HALE KIDS SUBDIVISION

Engineering Comments: FINAL PLAT COMMENTS (should be addressed prior to submitting the FINAL PLAT for review and/or signature by the City Engineer):

APPLICATION NUMBER 14 DATE October 1, 2020

DETAIL SITE PLAN

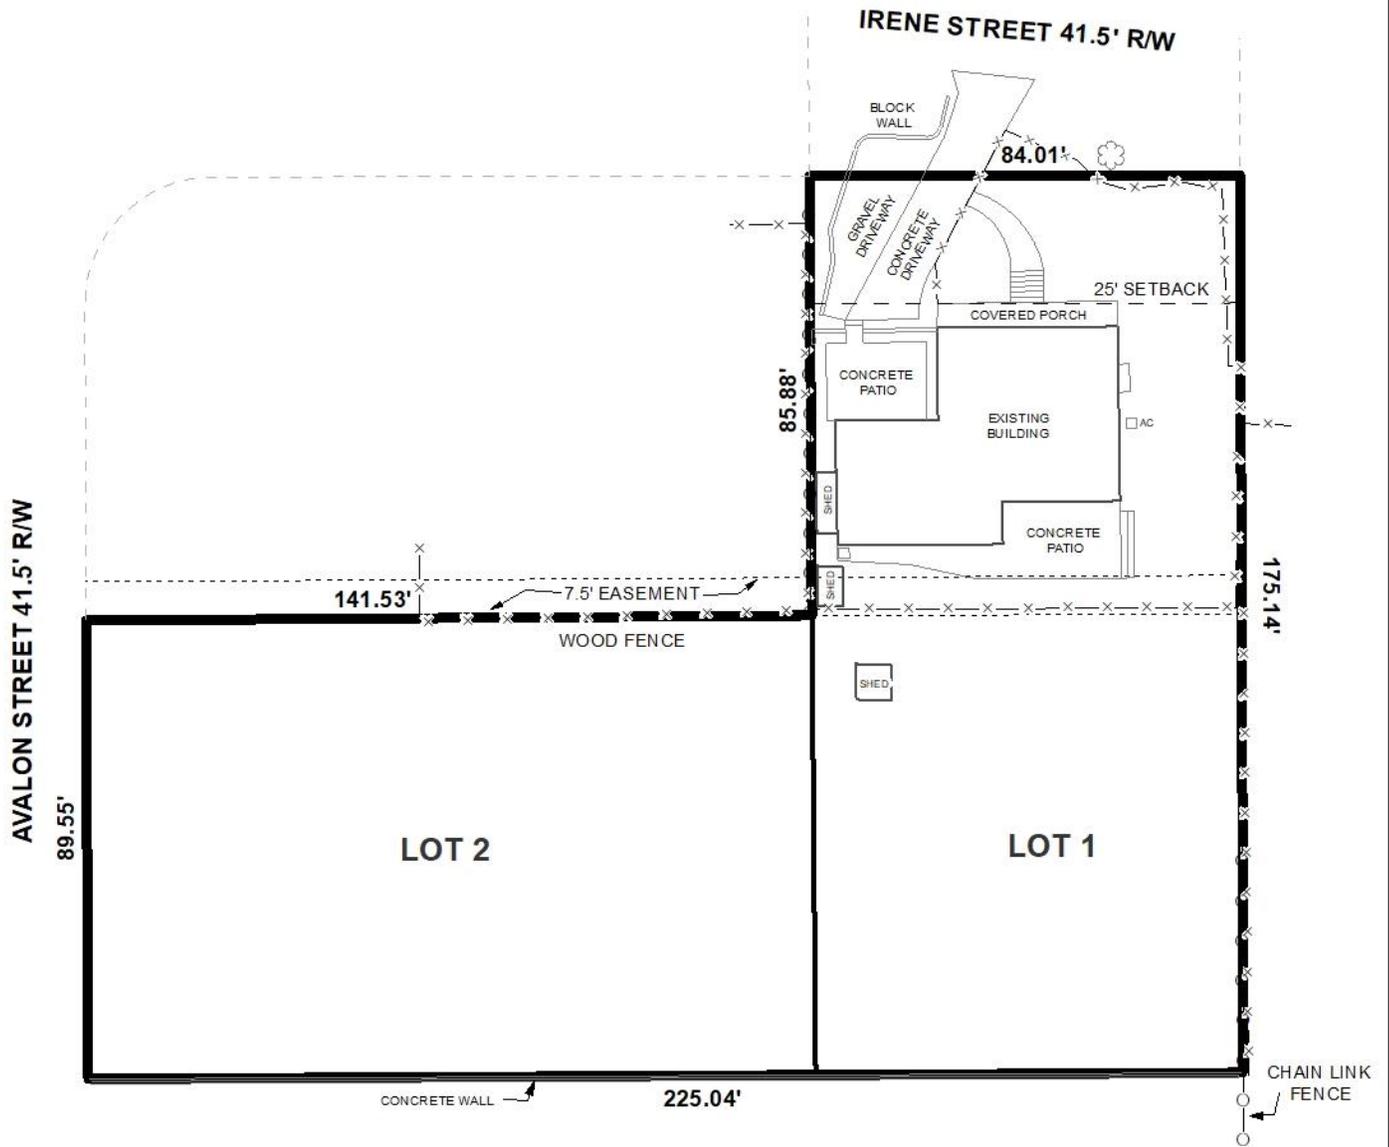
- B. Provide a thicker subdivision boundary line. All the line weights appear to be similar.
- C. Provide the Surveyor's and Owner's (notarized) signatures.

- D. Add a note to the SUBDIVISION PLAT stating that as shown on the 1984 aerial photo (FLIGHT 24 - #73) LOTS 1 and 2 will receive historical credit of existing (1984) impervious area towards stormwater detention requirement per Mobile City Code, Chapter 17, Storm Water Management and Flood Control) as follows: LOT 1 – 2,500 sf and LOT 2 – 2,200 sf.

As proposed, Lot 1 fronts Irene Street and Lot 2 fronts Avalon Street. Both are minor streets without curb and gutter illustrated on the preliminary plat as having substandard right-of-way widths of 41.5 feet. Section V.B.14. of the Subdivision Regulations requires a 60-foot right-of-

way width for minor streets not provided with curb and gutter. As such, dedication to provide 30 feet from the centerline of each road would typically be required. However, it should be noted that at its meeting on October 16, 2003 the Planning Commission approved a subdivision request which directly abuts to the East of the subject site requiring dedication only to provide 25 feet from the centerline of Irene Street. This 50-foot right-of-way width is further supported by a previously approved subdivision located 181'± South of the subject site at the corner of Avalon Street and Stillwood Lane West. The Viola E Powe resubdivision was approved in 1968 illustrating a distance of 25 feet to the centerline of Avalon Street. As this is in keeping with the surrounding area, a similar right-of-way width would be recommended for the subject site, and as such, Lot 1 would not require any dedication at this time. However, the preliminary plat does not illustrate the distance to the centerline of Avalon Street from the Western boundary of Lot 2 and dedication to provide 25 feet from the centerline may be necessary. If approved, a waiver of Section V.B.14. of the Subdivision Regulation may appropriate, and the Final Plat should be revised to label the right-of-way width for both Irene Street and Avalon Street adjusted for dedication, as appropriate.

As illustrated, both proposed lots will meet the minimum size requirements of the Subdivision Regulations and as such, the lot size label in both square feet and acres should be retained on the Final Plat or a table should be furnished on the Final Plat providing the same information. It should be noted that the preliminary plat illustrates a front setback for proposed Lot 1, but not proposed Lot 2. As such, the Final Plat should be revised to show a 25-foot minimum building setback along both frontages, adjusted for dedication, if necessary.

A 7.5-foot drainage and utility easement is indicated on the preliminary plat. This should be retained and a note should be placed on the Final Plat stating that no structure may be placed or constructed within any easement without the permission of the easement holder.

- 1) Dedication to provide 25 feet from the centerline of Avalon Street, if applicable;
- 2) Revision of the Final Plat to label the right-of-way widths for both Irene Street and Avalon Street, adjusted for dedication, as appropriate;

- 3) Revision of the Final Plat to illustrate a 25-foot minimum building setback for Lot 2 along Avalon Street, adjusted for dedication, if applicable;

- 4) Retention of the lot size in both square feet and acres, or the furnishing of a table on the Final Plat providing the same information, adjusted for dedication;

- 5) Retention of the 7.5-foot utility and drainage easement on the Final Plat;
- 6) Placement of a note on the Final Plat stating that no structure may be constructed or placed within any easement without the permission of the easement holder;
